Office Action Summary

10/083,093

DETAILED ACTION

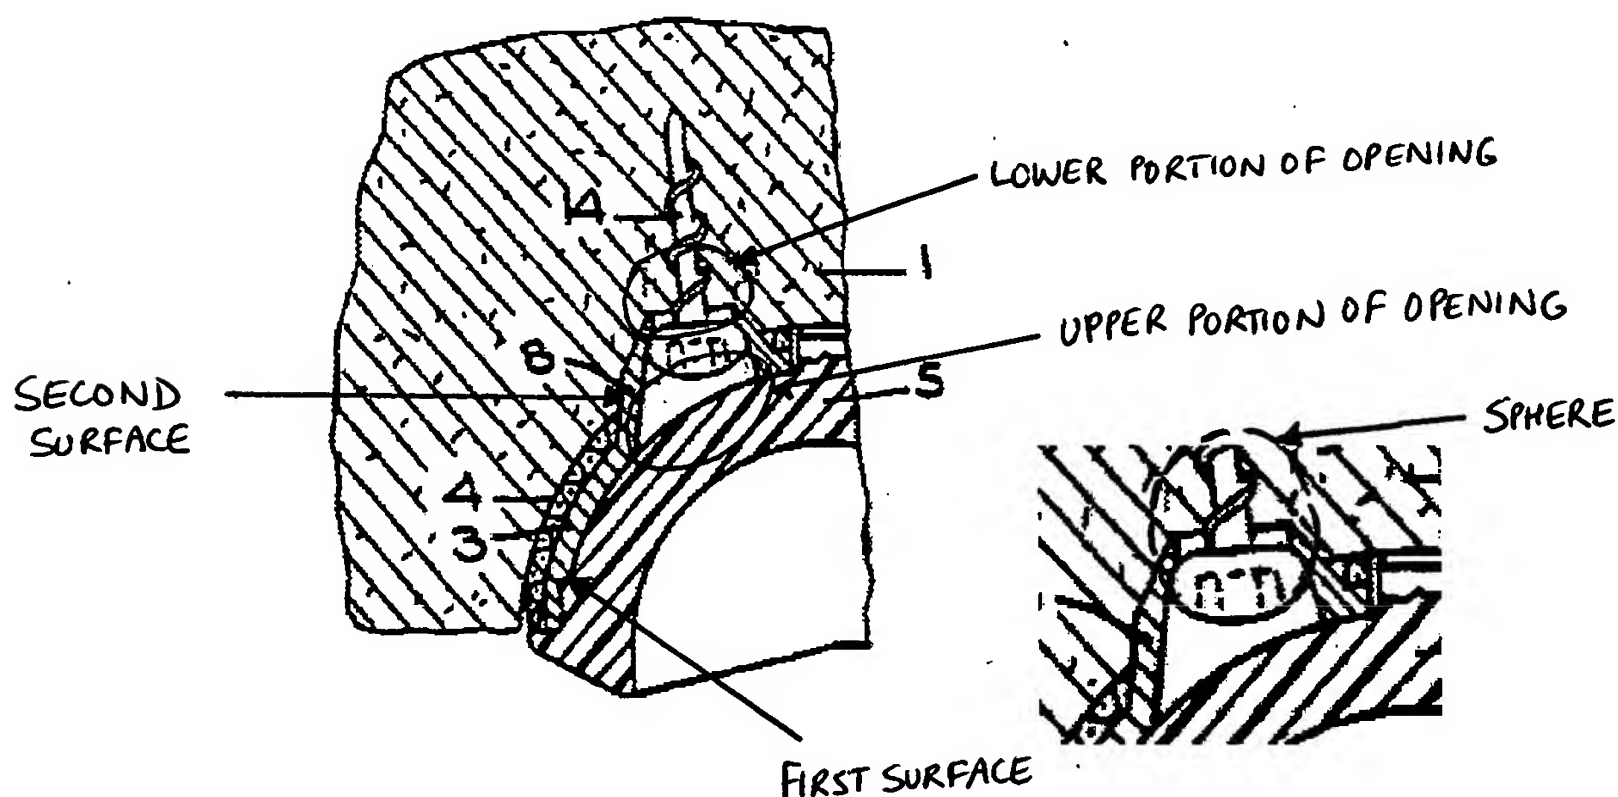
Marchetti et al. disclose an implantable prosthesis including: a metal shell or "prosthetic component" 3; at least one opening extending from a first surface to the second surface of component 3, the opening having a nonthreaded frustoconical upper portion and a lower portion; a screw or "insertion member" 14 with a rounded non-frustoconical contact surface that contacts the frustoconical taper section of the opening and does not contact the lower portion of the opening (Fig. 4, col. 2, lines 39-68 and col. 3, lines 1-44). See marked up Fig. 4 from Marchetti et al. below.

Regarding the limitation, "in a substantially fluid tight relationship" it is noted that the head of screw 14 forms a seal by the head of the screw abutting against the conical surface of the opening. Turning to Applicants' specification to determine what constitutes a "substantially fluid-tight seal," at page 23, line 21 and page 24, lines 1-2, Applicants' disclose that a head of an insertion member should be received and locked in a screw hole to provide "at least a partial seal." The screw 14 of Marchetti et al. forms "at least a partial seal" by being received and locked in the opening and thus fits in the opening in a "substantially fluid tight" relationship.

The rounded surface of the head of insertion member 14 is a slice or portion of a sphere as shown in marked up Fig. 4 below.

It is noted that the head of screw 14 abuts on the conical inner wall and thus provides a liquid-tight seal in that there is no opening or gap at the locking interface.

Regarding the rejection of claim 47 as being anticipated by Marchetti et al., the head of insertion member is part or slice of a sphere as previously discussed in this office action.

As previously stated, screw 14 of Marchetti et al. forms "at least a partial seal" by being received and locked in the opening and thus fits in the opening in a "substantially fluid tight" relationship.

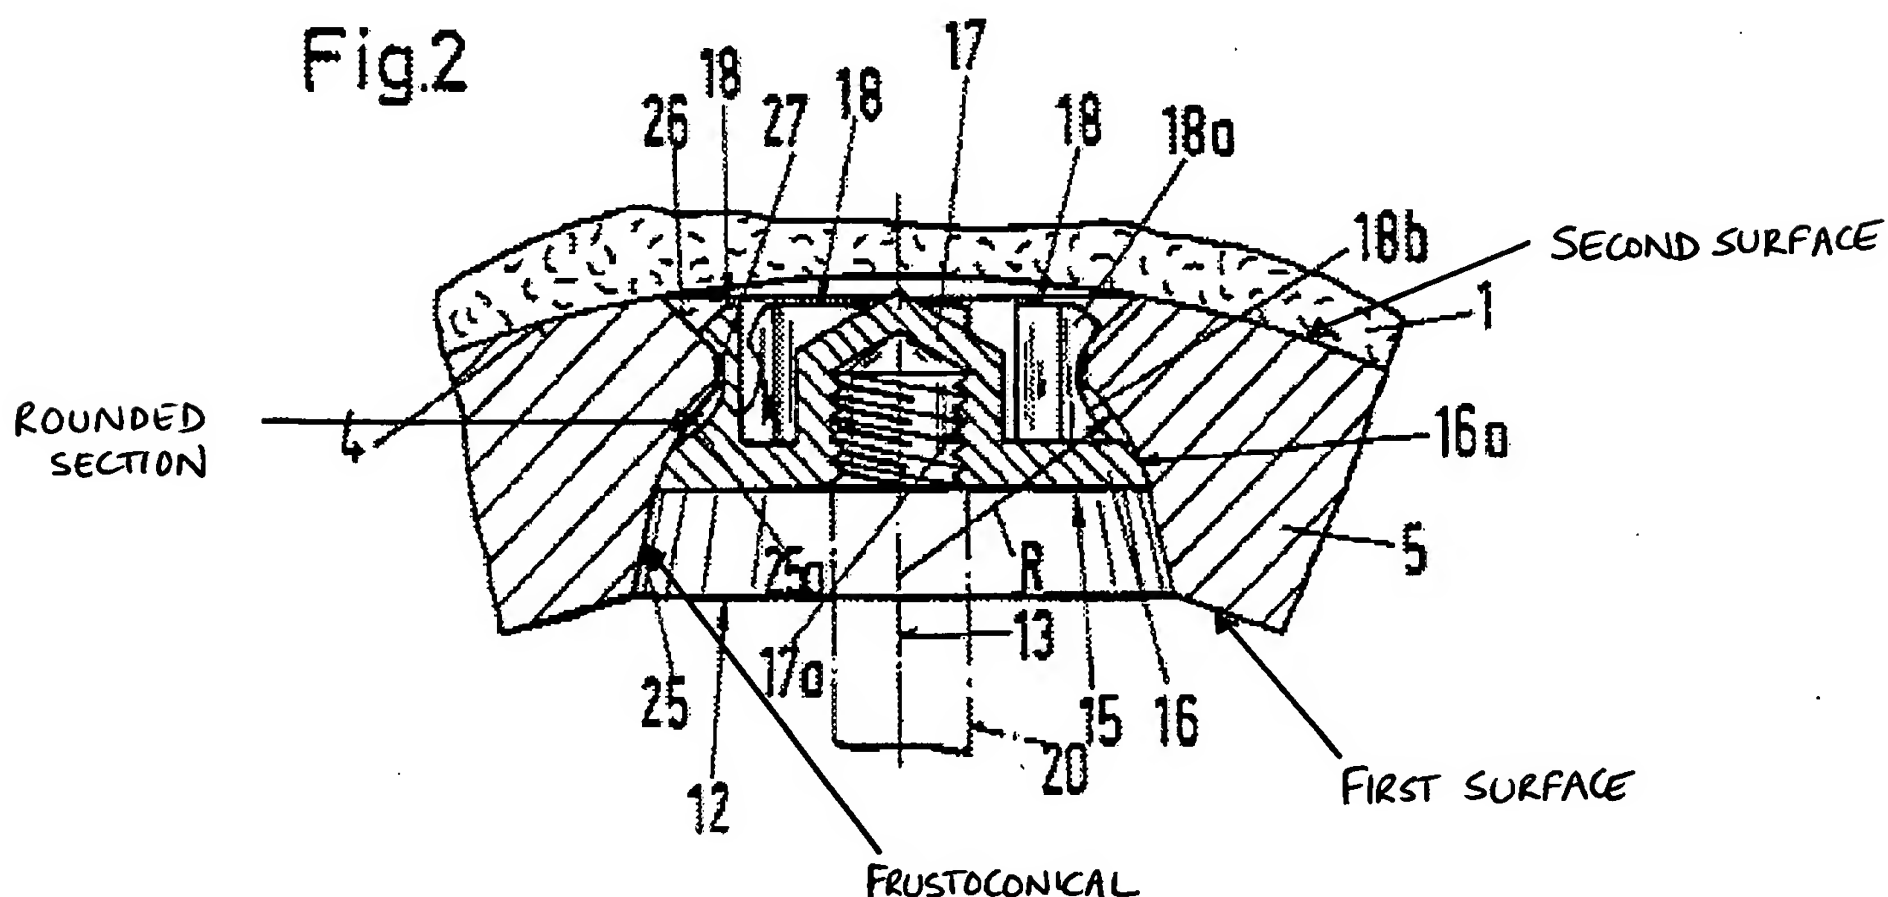
Claims 47-52 are rejected under 35 U.S.C. 102(b) as being anticipated by Oehy et al. (US 5,645,606).

Oehy et al. disclose an acetabular shell or cup 5 having: a first surface, a second surface oriented toward bone; openings 12 extending from the first surface to the second surface wherein each opening 12 has an extended nonthreaded frustoconical taper section 25, a rounded section with a concave surface 25a beginning at a narrow end of the frustoconical section; each opening 12 capable of receiving any type of fastening element or insertion member; an insertion member 14 having a head with a spherical undersurfaces 14a seatable in surface 25a in a plurality of angular positions (Figs. 1-2, col. 2, lines 45-67, col. 3 and col. 4, lines 1-6). See marked up Fig. 2 below.

Regarding the rejection of claim 47 as being anticipated by Oehy et al., Applicants' arguments are not directed to claim limitations. Applicants' arguments that Oehy et al. disclose a compression screw 14 that is not self-locking is directed to intended use with inadequate recitation of structure to distinguish over the Oehy et al. screw.
